**PROPOSED AMENDMENTS TO SERIES 6 OF REGULATION No. 14  
– SAFETY BELT ANCHORAGES, ISOFIX ANCHORAGES SYSTEMS AND ISOFIX TOP  
TETHER ANCHORAGES –**

Transmitted by the expert from CLEPA

Figure 11: Alternative method of locating the top tether anchorage using the "ISO/F2" (B) fixture, ISOFIX zone - Side, top and rear views

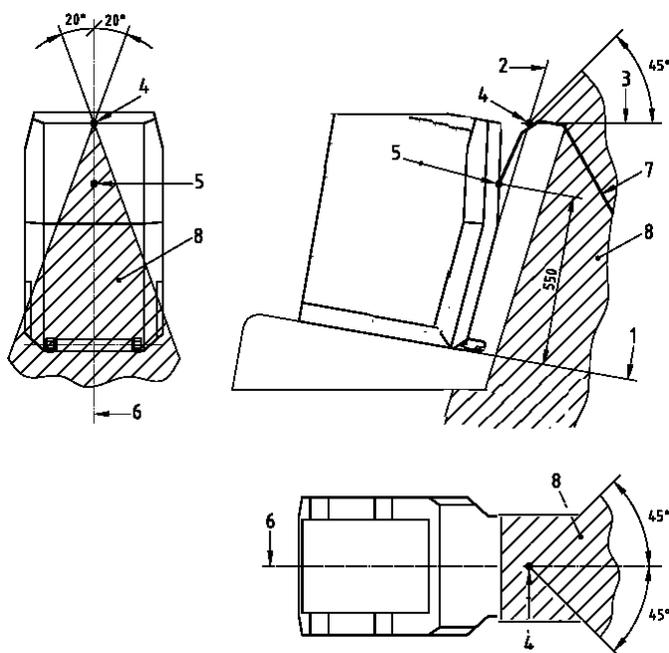
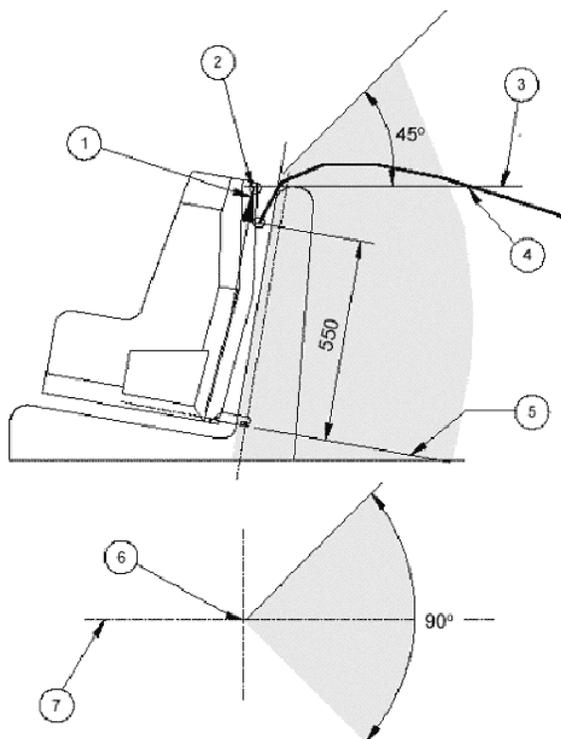
Annex 9, figure 11, amend to read :

- 1 "ISO/F2" (B) fixture horizontal face
- 2 "ISO/F2" (B) fixture rear face
- 3 horizontal line tangent to top of seat back (last rigid point of a hardness greater than 50 Shore A)
- 4 intersection between 2 and 3
- 5 tether reference point
- 6 "ISO/F2" (B) fixture centreline
- 7 top tether strap
- 8 limits of anchorage zone

The construction zone described today in paragraph 5.2.4.2. and figure 11 of annex 9 is not very clear and is explained as followed :

Following points are not explained which are essential for the construction of the zone:

- Position of the seat for the construction of the top tether zone
- CRF vertical reference probe (point 1 in the figure)
- Isofix vertical reference line (described in paragraph 5.2.4.2.)
- Top tether reference line (point 2 in the figure)
- Horizontal line (point 3) and plane containing the underside of the seat top bar (described in paragraph 5.2.4.2.)
- Tether reference point (point 6 in the figure)
- How the line limiting the top tether zone at 45° is constructed ?

The modification of paragraph 5.2.4.2. and figure 11 of annex 9 would provide such clarifications.

**In the side view, the ISOFIX top tether anchorage shall lie behind the "ISO/F2" (B) fixture rear face.**

**The intersection between the "ISO/F2" (B) fixture rear face and the horizontal line (annex 9, figure 11, reference 3) containing the last rigid point of a hardness greater than 50 Shore A at the top of the seat back defines the reference point 4 (annex 9, figure 11) on the centreline of the "ISO/F2" (B) fixture. At this reference point, a maximum angle of 45° above the horizontal line defines the upper limit of the top tether anchorage zone.**

**In the top view, at the reference point 4 (annex 9, figure 11), a maximum angle of 90° extending rearward and laterally and in the rear view, a maximum angle of 40° define 2 volumes which limit of the anchorage zone for the ISOFIX top tether.**

The origin of the ISOFIX top tether strap (5) is located at the intersection of the "ISO/F2" (B) fixture with a plane 550 mm distant above the "ISO/F2" (B) fixture horizontal face (1) on the "ISO/F2" (B) fixture centreline (6).

Further, the ISOFIX top tether anchorage shall be more than 200 mm but not more than 2000 mm from the origin of the ISOFIX top tether strap on the rear face of the "ISO/F2" (B) fixture, measured along the strap when it is drawn over the seat back to the ISOFIX top tether anchorage.
